ENERGY FIJI LIMITED

**ENGINEERING, PROCUREMENT AND
CONSTRUCTION (EPC) OF 11kV/33kV
SUBSTATION for 30MW POWER STATION AT
VUDA**

TENDER NO: MR 121/2024

Addendum No. 1

PROPOSED LAND USAGE FOR THE
NEW THERMAL GENERATION
PROJECT AT VUDA

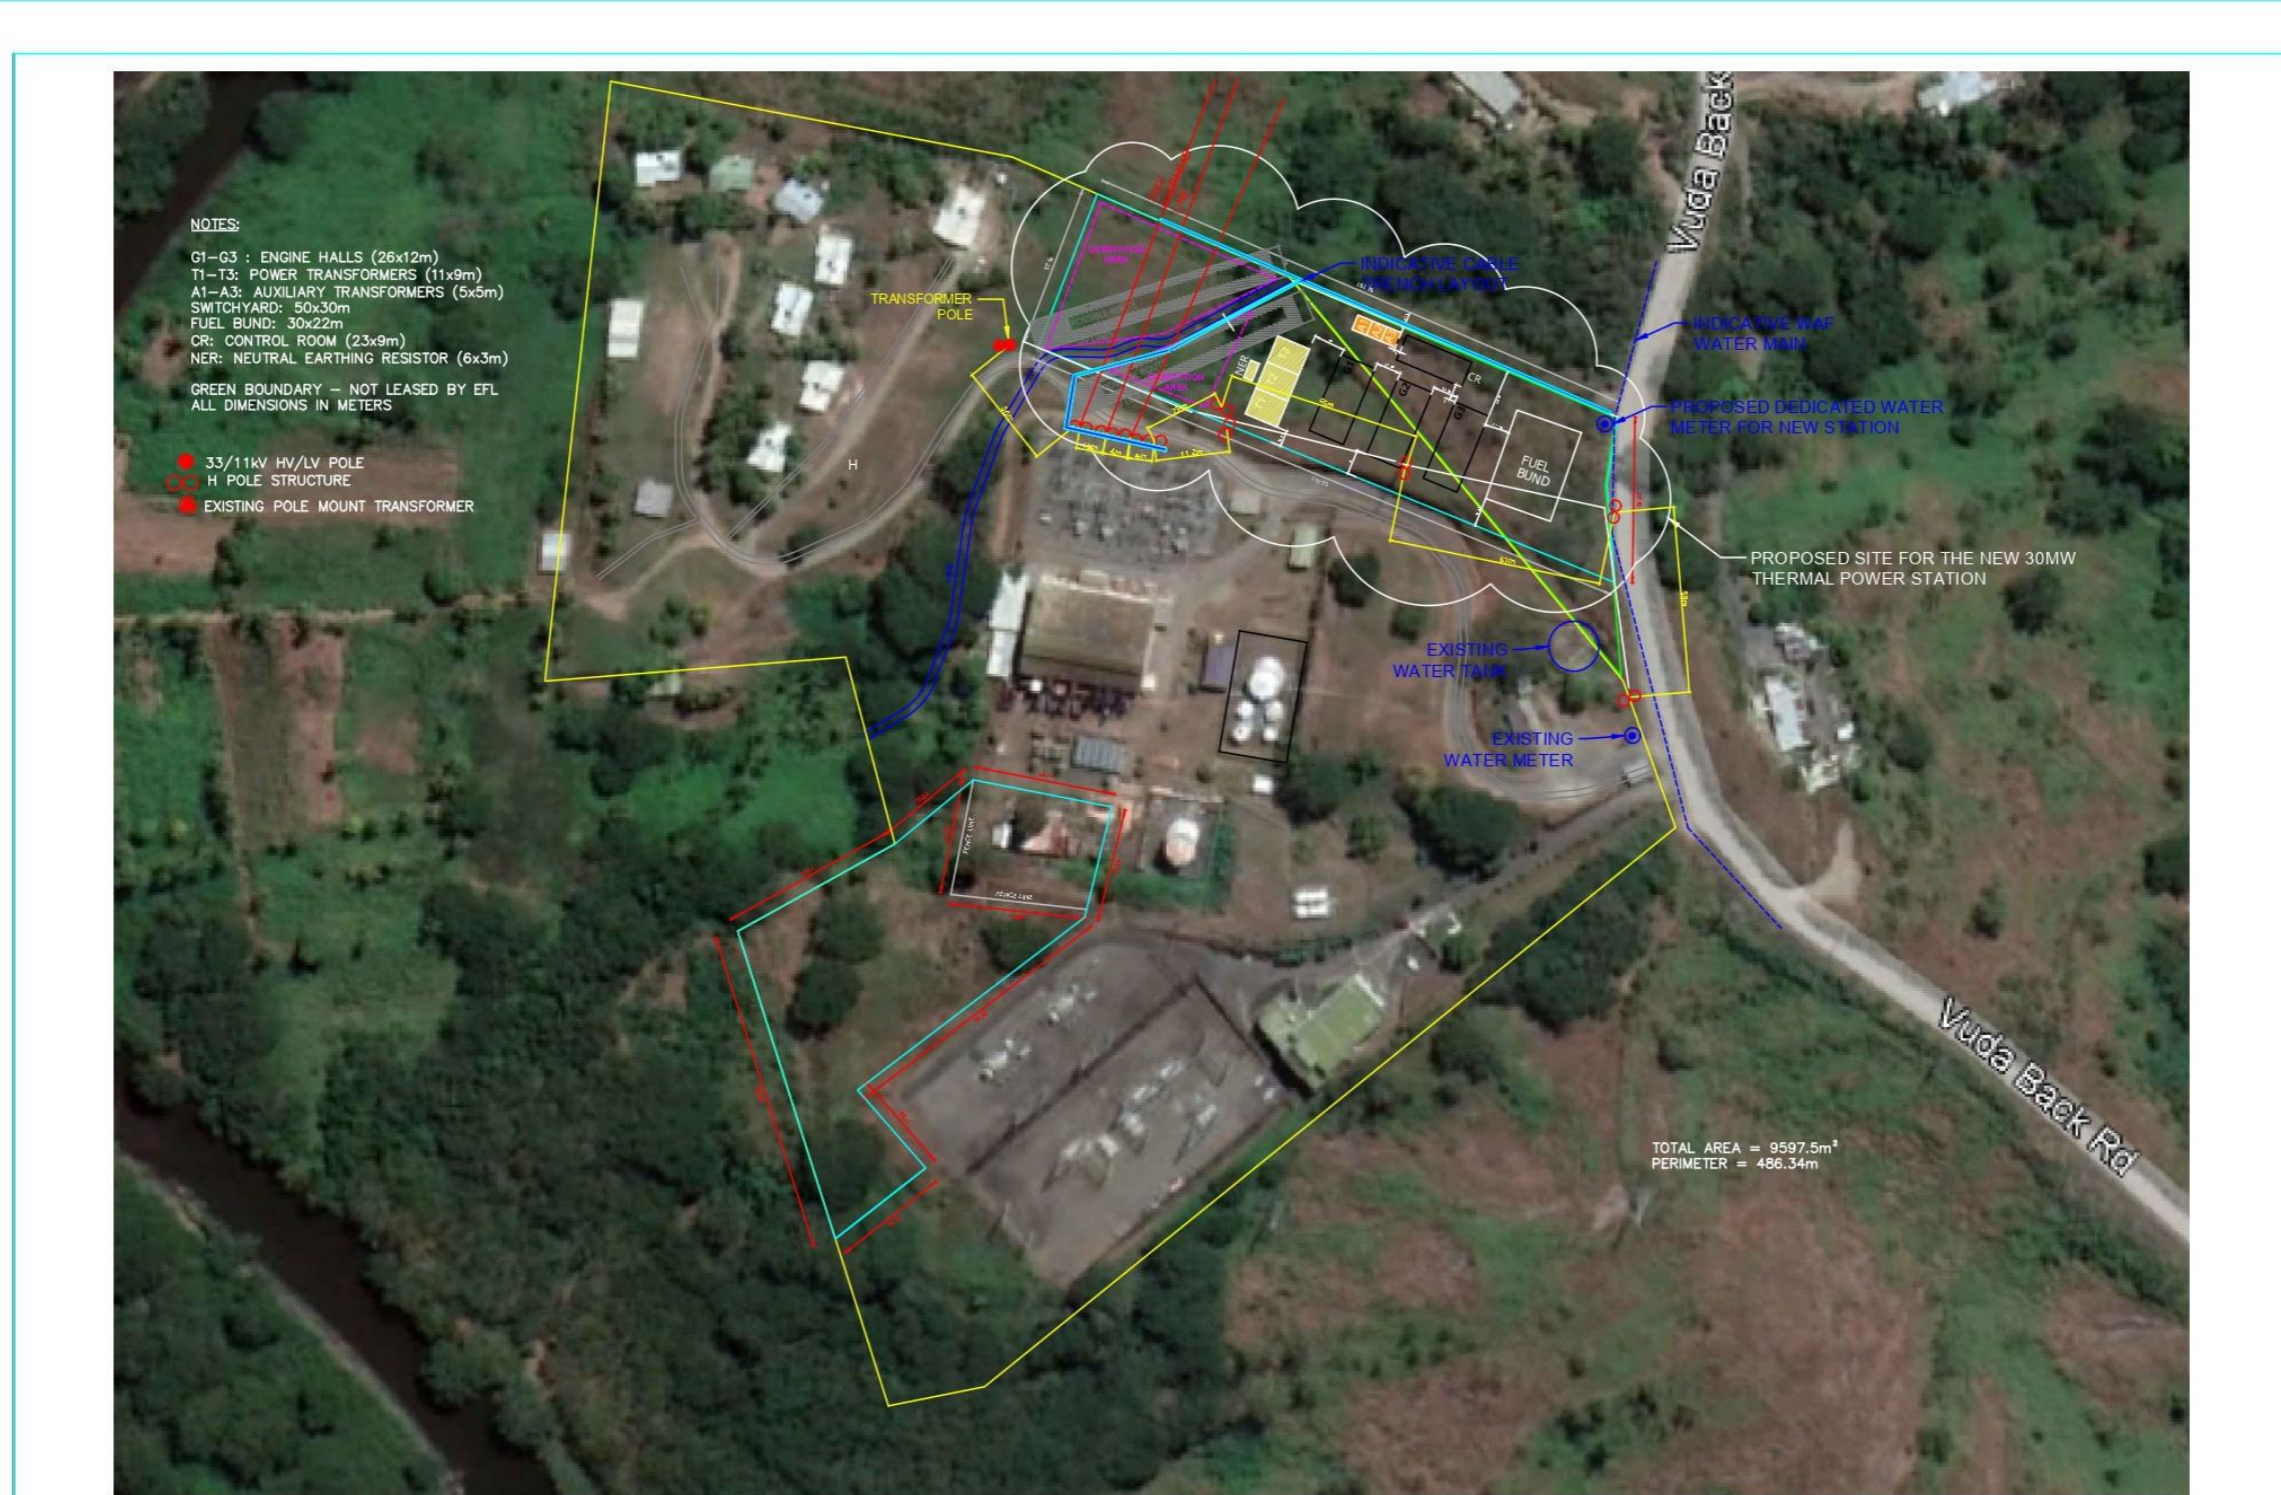
| No | Description |
|----|---|
| 2 | <p>Section 10: Drawings</p> <p>Replace</p> <p><i>“Indicative Layout of Existing Vuda Substation with New Generation Project, Drawing Number A3 01 ”</i></p> <p>With</p> <p><i>“Indicative Layout of Existing Vuda Substation with New Generation Project Drawing Number 02-E10-VDNEW-SK01 rev 02”</i> refer Appendix 1.</p> |
